CITY OF SURPRISE
Planning and Zoning Commission Agenda
16000 N. Civic Center Plaza
Surprise, AZ 85374

Thursday, January 21, 2016 @ 6:00 PM
 COUNCIL CHAMBERS

A. Site Plan Sheet C1 prepared by PM Design stamped received December 11, 2015 to be revised as follows:

FS15-410 O'Reilly Auto Parts Site Plan Amendment

La.01

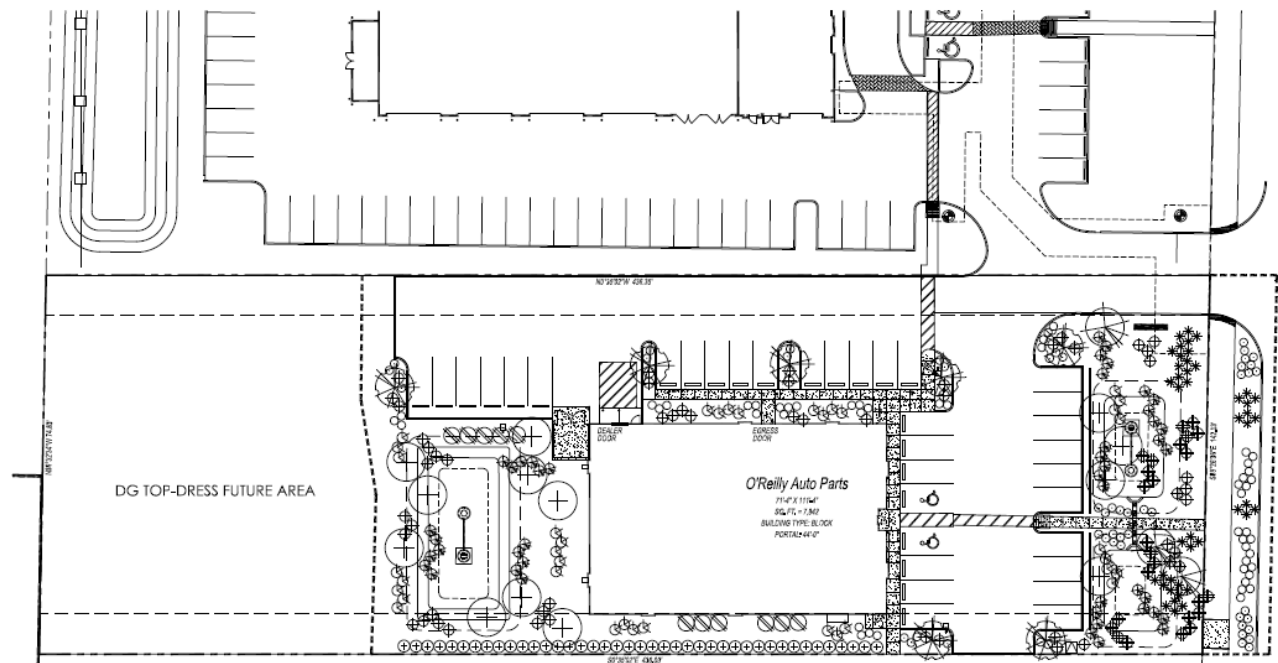
C. Landscape Plan Sheet La.01 prepared by PM Design stamped received December 11, 2015 to be revised as follows:

1. Prior comments asked that you revise the base drawing and Site Data table per above site plan comments where appropriate; however, the Site Data table was not revised nor was the configuration of the south end of the site relative to fire turnaround. Also, the SVT is missing.
2. Related to the previous comment, be sure to set the SVT at the right-of-way line and shift the monument sign out of the SVT per Sheet C1 comments.

- 241
- 242 b. The landscape plan prepared by PM Design, date signed December 8, 2015 will be
- 243 revised and submitted for review to include the following modifications:

- 244
- 245 1. Revise the Site Data table consistent with the site plan.
 - 246
 - 247 2. Revise the configuration of the south end of the site relative to fire turnaround.

- 248
 - 249 3. Add the sight visibility triangle per EDS 4-02.
 - 250
 - 251 4. Shift the monument sign out of the sight visibility triangle.
 - 252
- 253 c. The site lighting photometric plan prepared by PM Design, date signed December 10,

Formed Embossed Cloud Logo
AUTO PARTS Channel Letters
with Formed Embossed Caps
63/31-L-CldLogo&Chltrs-WFC

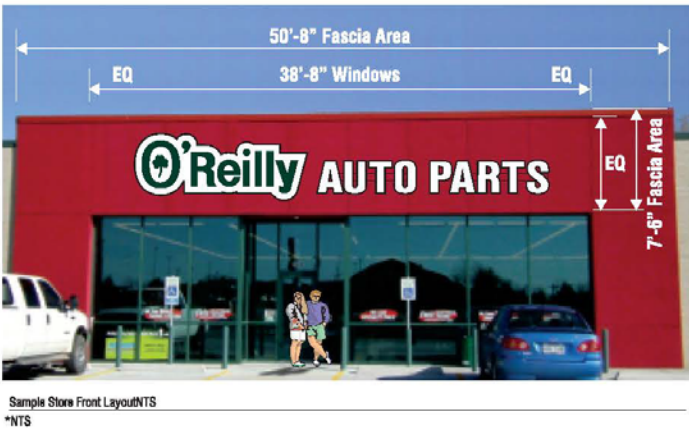
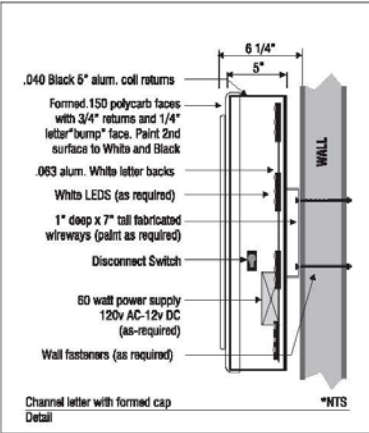
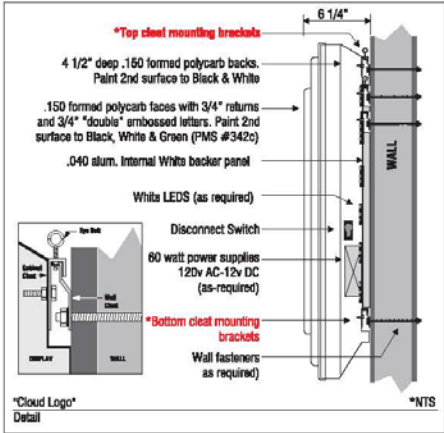
D. Sign Package prepared by O'Reilly Automotive stamped received December 11, 2015 to be revised as follows:

1. Prior comments asked that you reduce the size of the wall sign to 50.67 square feet of wall sign based on a ratio of 1 square foot per linear foot of elevation. Upon further review, however, the 50.67 figure comes from the manner in which the elevation is expressed on this drawing when in reality the front elevation is 71'-4" wide per Sheet C1. Please revise the sign package to show the entire front elevation at 71'-4" and base the sign area calculation on that figure i.e. 71.33 square feet maximum.

- d. The sign package prepared by O'Reilly Automotive, submitted December 11, 2015 will be revised and submitted for review to show the entire front elevation at 71'-4" and to base the sign area calculation on that figure i.e. 71.33 square feet maximum.

SITE PLAN

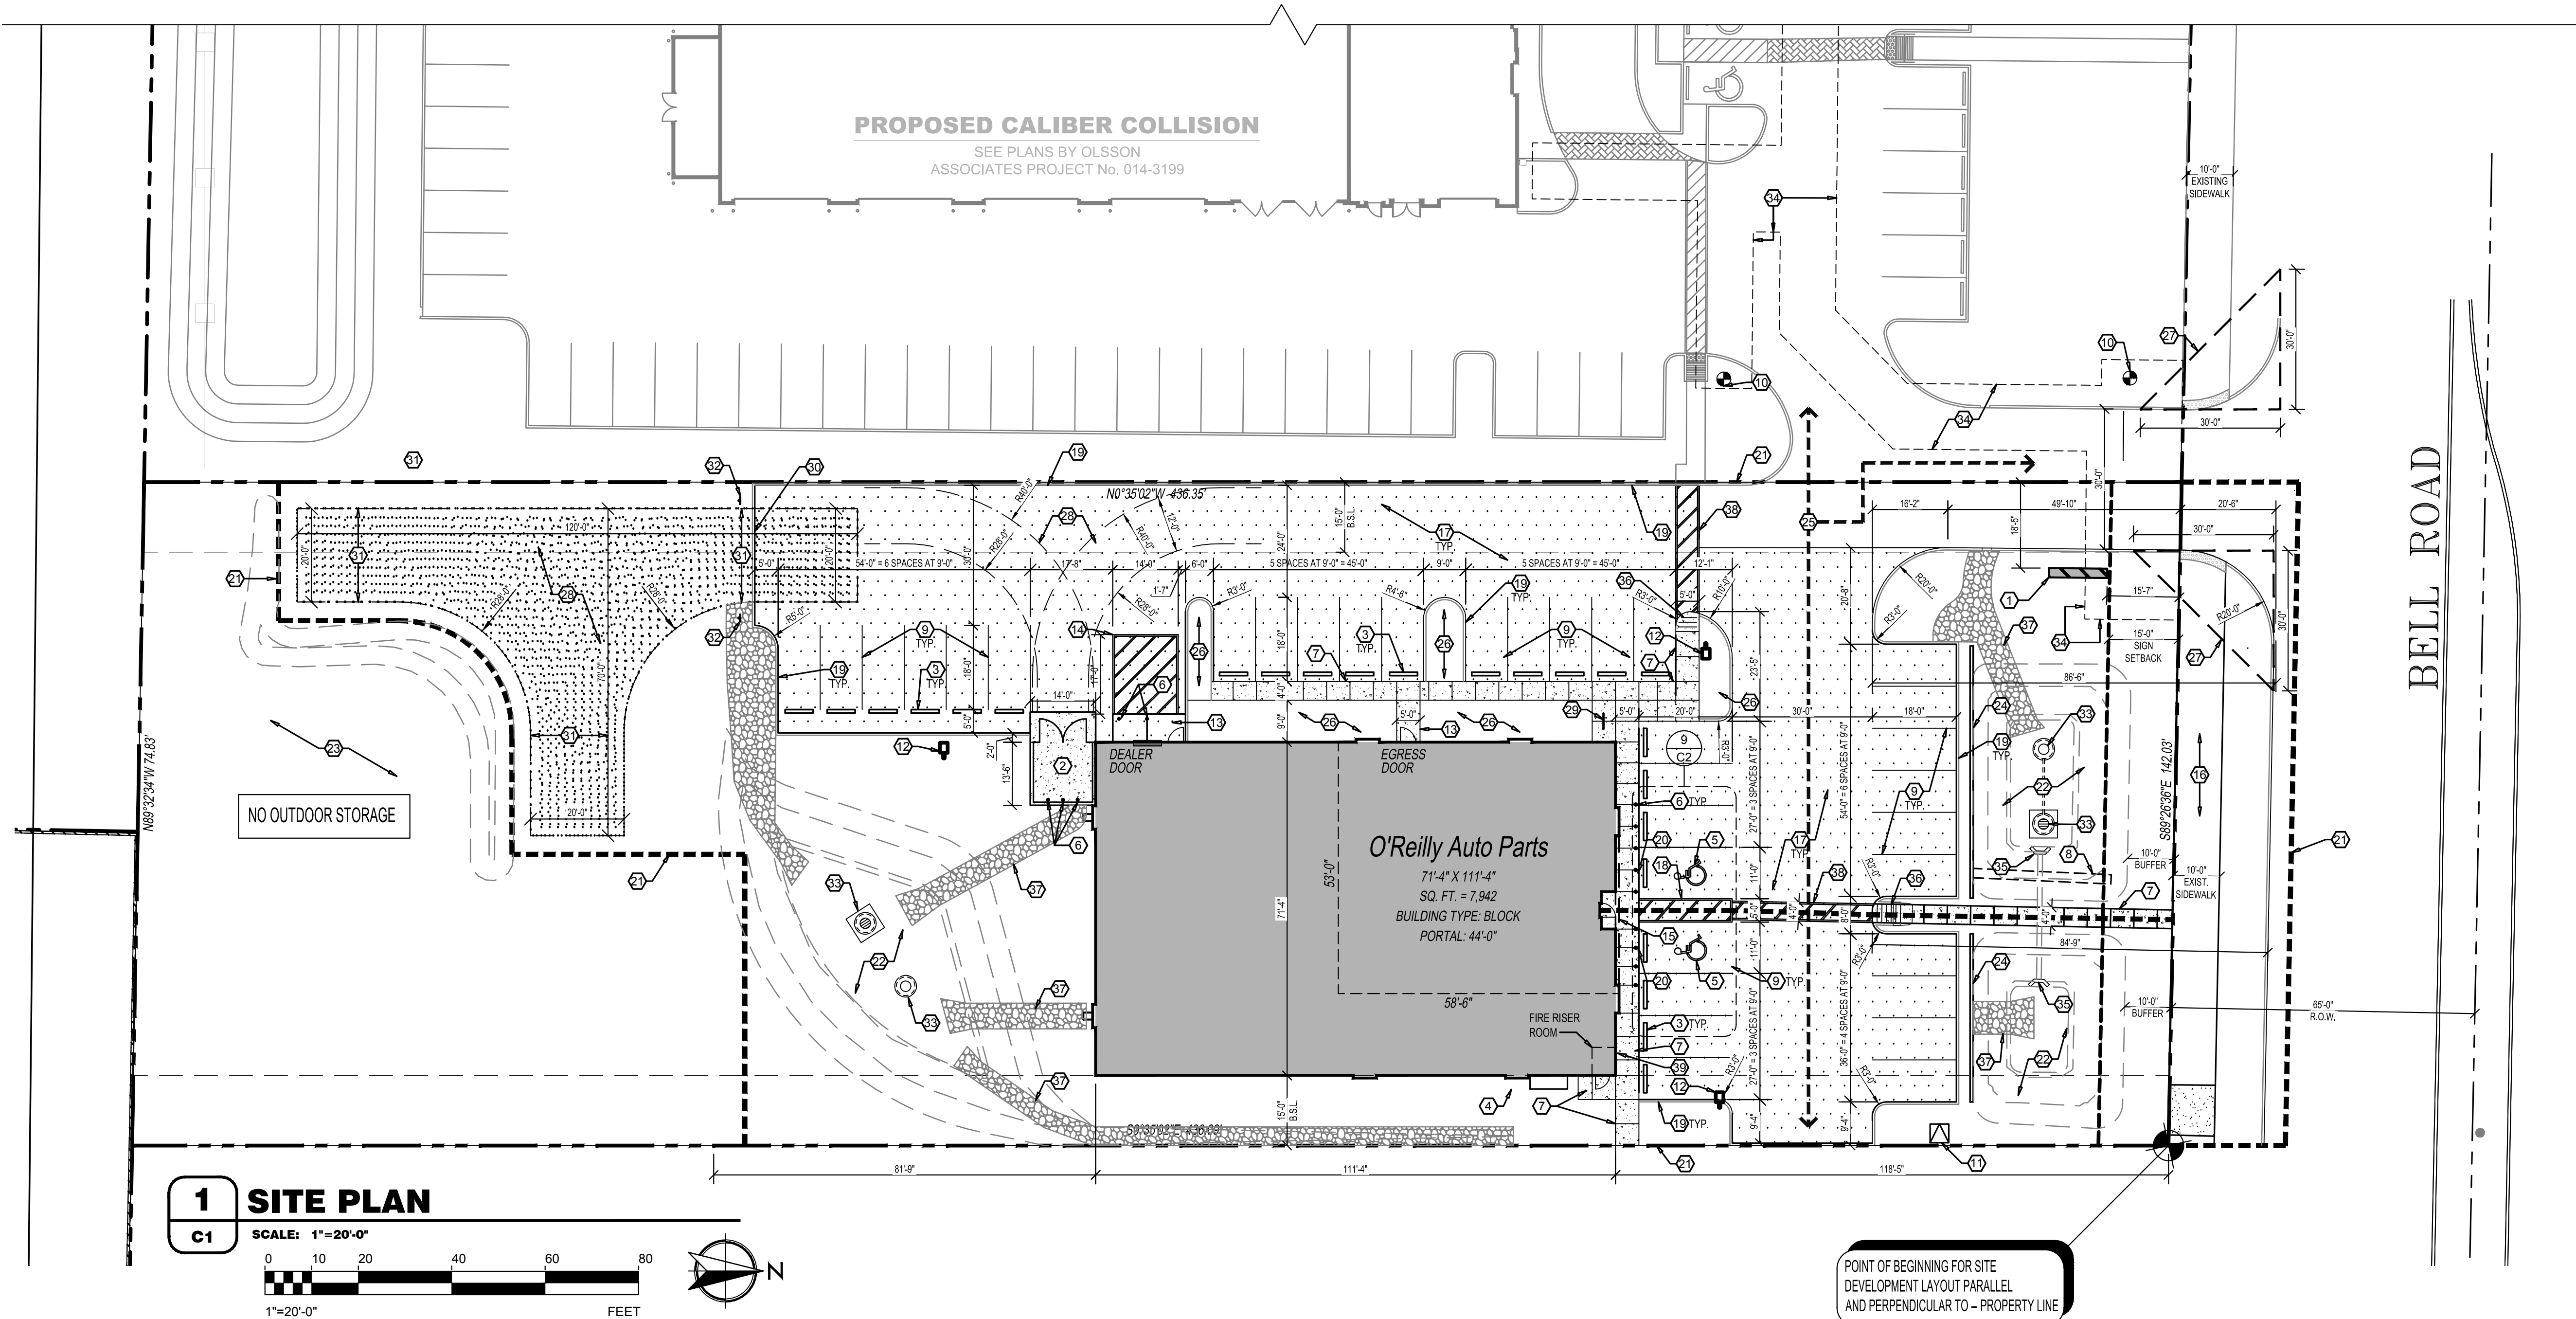
1. Prior comments asked that you show a 30' sight visibility triangle at the entrance per EDS 3-02. You included that SVT, but set the base of the triangle at the Bell Road curb line as opposed to the right-of-way line as required by the standard detail. Please set the SVT at the ROW line.

2. Prior comments asked that you shift the proposed monument sign out of the sight visibility triangle and that you maintain a 15' setback for the sign. You shifted the sign back, but it still conflicts with the location of the required SVT. Please shift the sign out of the SVT while continuing to maintain a 15' sign setback. (See clouded area above.)
3. New comment based on new information – the paving surface for the fire turn-around area is not clearly indicated. Please call out the paving surface for this area, making sure that it meets the Fire Department's requirements for structural stability.

- 230 a. The site plan prepared by PM Design, date signed December 09, 2015 will be revised
- 231 and submitted for review to include the following modifications:

- 232
- 233 1. Set the sight visibility triangle at the right-of-way line per City of Surprise
 - 234 standard detail EDS 4-02.
 - 235
 - 236 2. Shift the sign out of the sight visibility triangle while continuing to maintain a 15'
